RE: Response to Data Request #1 for the Gates 500 kV Dynamic Reactive Support Project

**LSPGC Gates Dynamic Reactive Support Project (A. 21-02-018)
 Energy Division Data Request #1 Date March 25, 2021
 LSPGC Response #1 Date April 15, 2021**

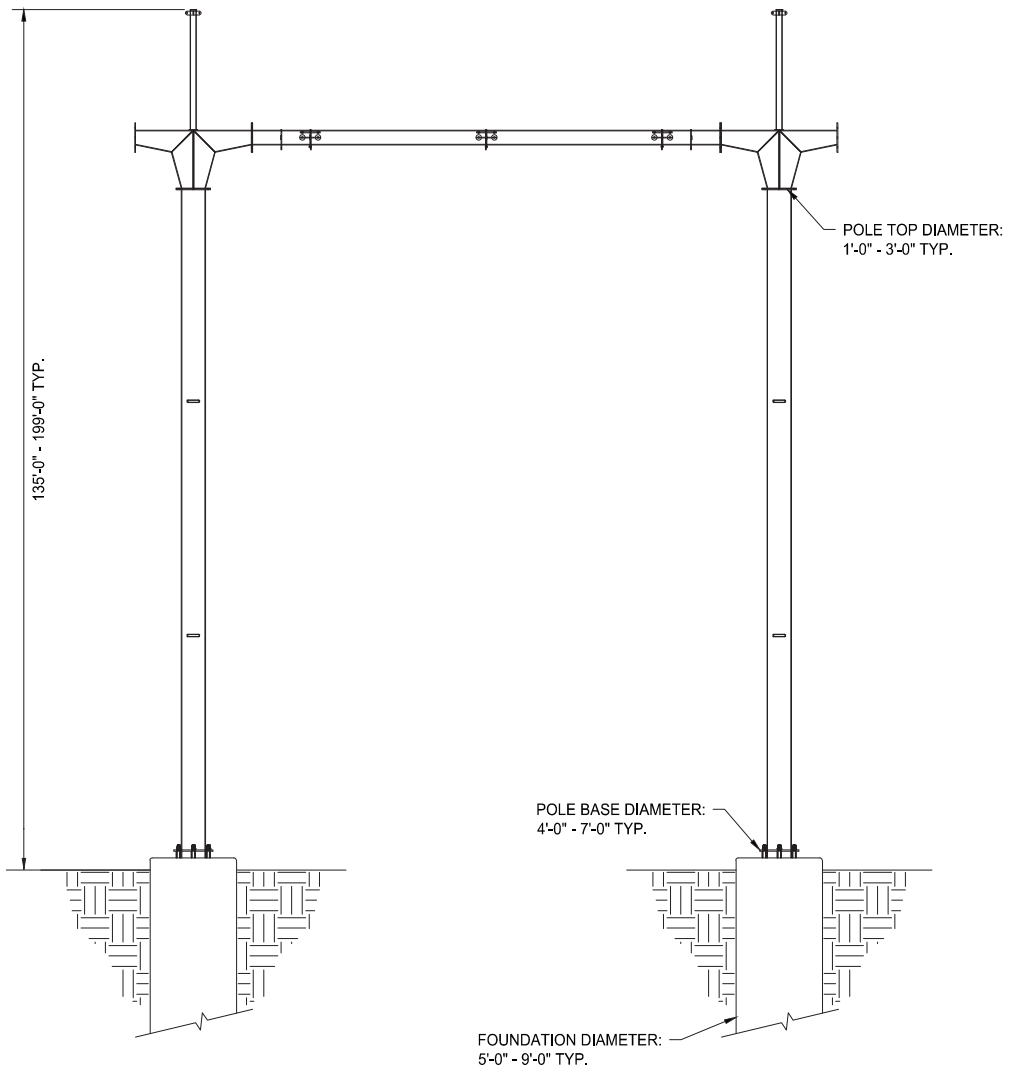
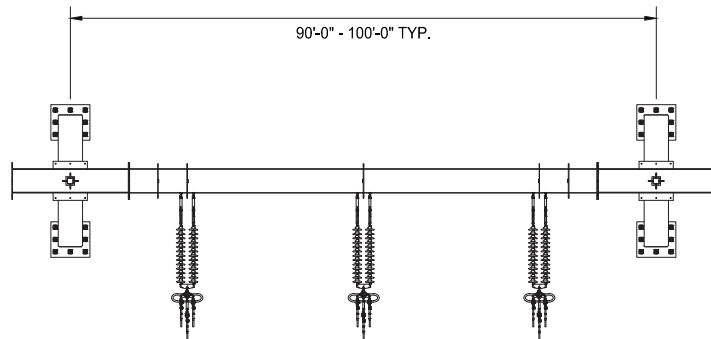
LSPGC Gates Dynamic Reactive Support Project (A. 21-02-018) Data Request #1							
Request No.	DATA REQUEST	LSPGC RESPONSE					
		500 kV Circuit Breakers	Slab	15	9	N/A	2.5
		Spare Parts and Maintenance Tool Storage Pads	Slab	25	25	N/A	2.5
		Cooling Equipment	Slab	25	80	N/A	2.5
2	Section 3.3.4.1, first paragraph on page 3.0-5: Provide an illustration/drawing of the take-off towers and lightning shielding masts, including heights and other dimensions.	See attached Take-off Tower Exhibit . The lightning shielding masts are the tall structures shown adjacent to the converter and control building in PEA Figure 3-6, STATCOM Substation Profile and will be approximately 75 feet in height.					
3	Section 3.3.4.1, first paragraph on page 3.0-5: “The take-off towers would be set approximately 20 to 25 feet below ground level.” Clarify that the take-off towers would not be directly embedded into the soil. PEA Section 3.3.5.1 indicates that the towers would be installed on pier foundations.	The take-off towers will be set on concrete pier foundations, 20 to 25 feet below ground-level.

**Figure 3-3
STATCOM Substation Diagram**

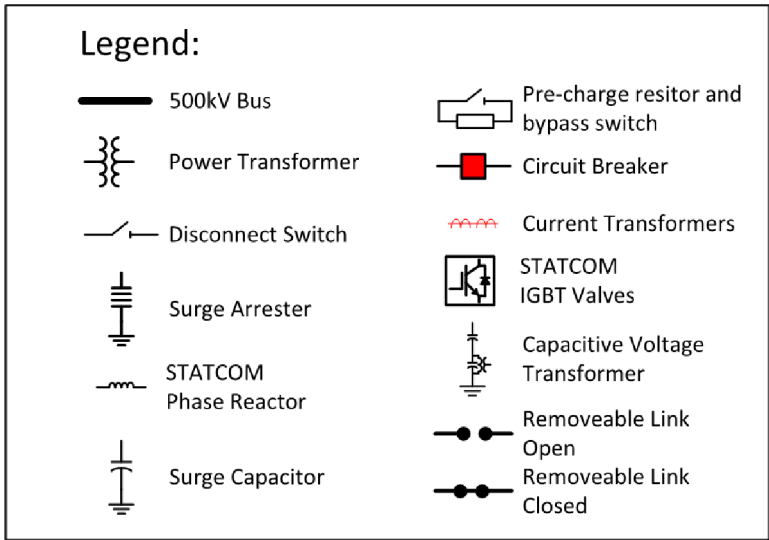
Request No.	DATA REQUEST	LSPGC RESPONSE
9	PEA Figure 3-3. Provide narrative that walks the reader through the system shown in PEA Figure 3-3. E.g., what do the red boxes, red arrows, etc., represent and what functions do they serve, and what process occurs at each facility in the STATCOM block. Also, revise the figure to point out some of the main ancillary components identified in the bullet lists on PEA pages 3.0-4 and 3.0-5.	<p>See attached revised Figure 3-3, STATCOM Substation Diagram that illustrates the electrical integration of the proposed STATCOM Substation facility and the existing PG&E Gates Substation. The main components of the electrical functionality of facilities, including the transformers, STATCOM reactors, disconnect switches and circuit breakers are labeled accordingly. The red arrows on the diagram illustrate the newly stabilized 500 kV power being directed back to the PG&E Gates Substation. The following is a description of the major substation equipment and their proposed functions:</p> <ul style="list-style-type: none"> • Transformers – Electrical equipment that transforms electric current from one voltage to another. • STATCOM Reactors – Electrical equipment that removes harmonics from the electric current and smooths the current waveform. Provides for system stability. • Disconnect Switches - Electrical equipment that provides a means of isolating one piece of equipment from another. Primarily used for equipment maintenance. For the Proposed Project, the disconnect switches will be used to isolate the STATCOM Substation from the PG&E Gates Substation. • Circuit Breakers - Electrical protection device that is used to isolate equipment in the event of a system fault. Provides both safety and equipment protection.

Figure 3-4 Project Overview

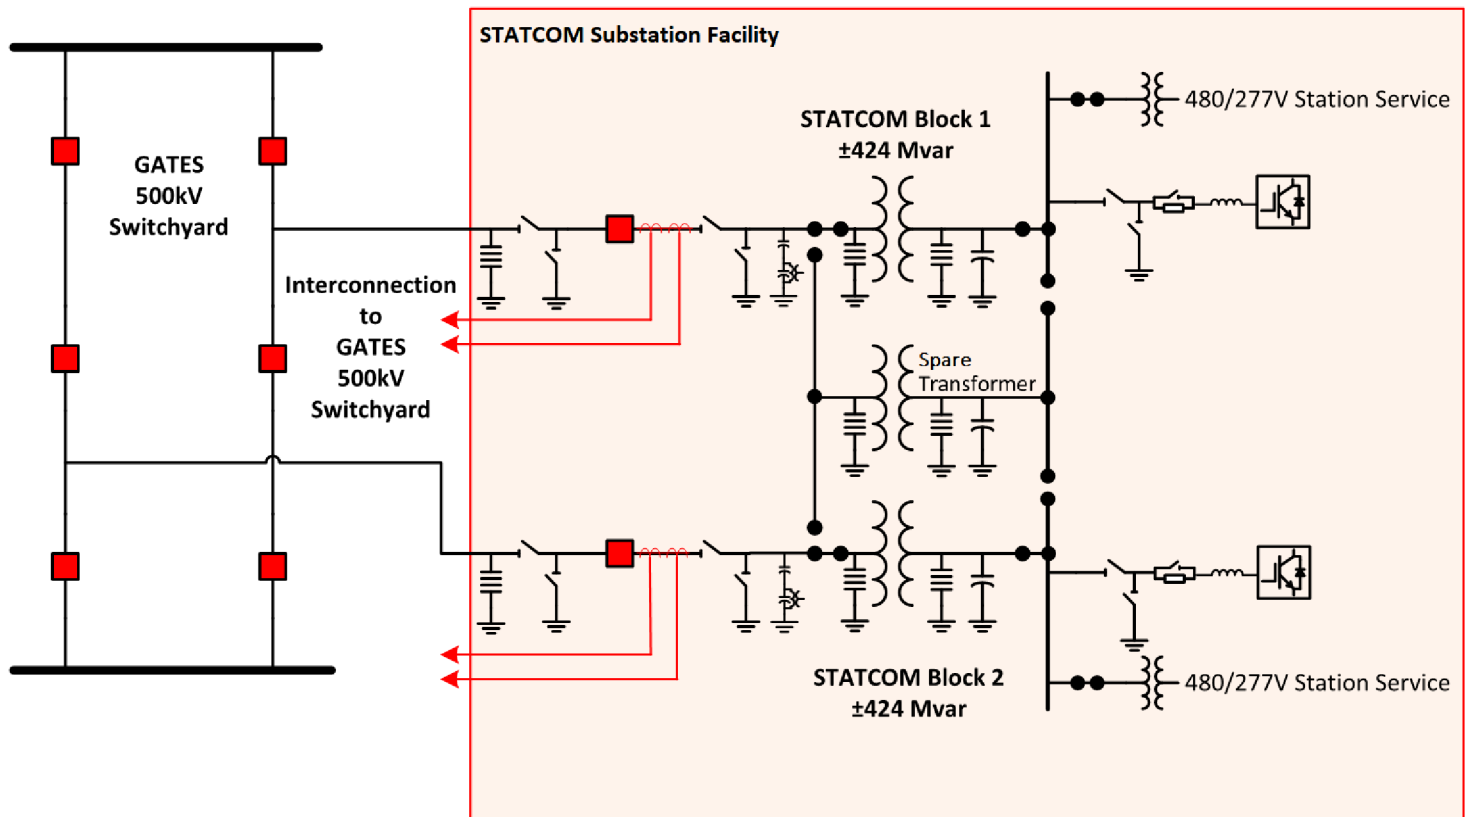
16	It has come to our attention that PG&E has expressed concern regarding granting LSPGC an easement for the north-south access road east of Gates Substation, and LSPGC is considering new access road options to the west of Gates Substation. Provide details for all possible access road options to the Project site, including text descriptions, revised figures, GIS data, and any associated revisions to construction information, such as disturbance areas, gravel volumes, etc.	<p>LSPGC has developed an alternative exterior access road option (to be included in the Proposed Project’s CEQA document) in addition to the primary north-south exterior access road option as described in the PEA (part of which is located on PG&E property).The alternative exterior access road option will be located completely on private property not owned by PG&E, west of the PG&E Gates Substation and solar arrays. The alternative exterior access road will span two private properties APN 075-060-665 and APN 075-600-067S (i.e., the Proposed Project site) for a total approximate length of 6,600 feet (1.25 miles). The approximately 20 foot wide alternative exterior access road will be graded flat and gravel or base rock will be used to create an all-weather, dust resistant surface. As with the primary exterior access road, the final 100 feet of the alternative exterior access road’s approach to West Jayne Avenue will be paved. The total disturbance area for the alternative exterior access road is approximately 3.1 acres. See revised Figure 3-4, Project Overview for the location of the proposed alternative exterior access road.</p> <p><u>New or Modified Rights-of-Ways or Easements</u></p> <p>The alternative exterior access road will require an approximately 35 foot wide, 0.56 mile long easement on APN 075-060-665 and a 35 foot wide, 0.69 mile long easement (or may be purchased in fee) on APN 075-600-067S, which is the same property that the STATCOM Substation facility will be located on. The granting of the alternative exterior access road easements will not require the</p>

LSPGC Gates Dynamic Reactive Support Project (A. 21-02-018) Data Request #1		
Request No.	DATA REQUEST	LSPGC RESPONSE
		<p>relocation or demolition of commercial or residential property or structures. Use of the easement areas will be restricted to underground telecommunications and access rights only.</p> <p><u>Grading Summary</u></p> <p>The alternative exterior access road will require minimal grading and improvements as the area is already relatively flat. In order to create a four-to-eight-inch road base, construction of the alternative exterior access road will require approximately 5,000 cubic yards of gravel or base rock to be imported.</p> <p><u>Telecommunications</u></p> <p>If the alternative exterior access road alignment is selected, the alternative primary telecommunications line will also be used. The alternative primary telecommunications line connection will start approximately 750 feet east of the intersection between the alternative exterior access road and West Jayne Avenue, along the northern shoulder of the road. From there, the telecommunications line will turn north along the portion of the alternative exterior access road that runs north-south, west of and parallel to the solar array field. The telecommunications line will then turn east and run along the east-west portion of the alternative exterior access road before being routed into the STATCOM Substation facility. See revised Figure 3-4, Project Overview for the location of the proposed alternative primary telecommunications line.</p> <p>Regardless of which primary telecommunication line arrangement is selected, the secondary telecommunication line will still be routed along the east-west access road and then north-south along the eastern property boundary of the PG&E Gates Substation for approximately 2,500 feet. The secondary telecommunication line will then connect to an existing telecommunication line that runs diagonally into the PG&E Gates Substation.</p> <p><u>Utilities (Distribution Power)</u></p>
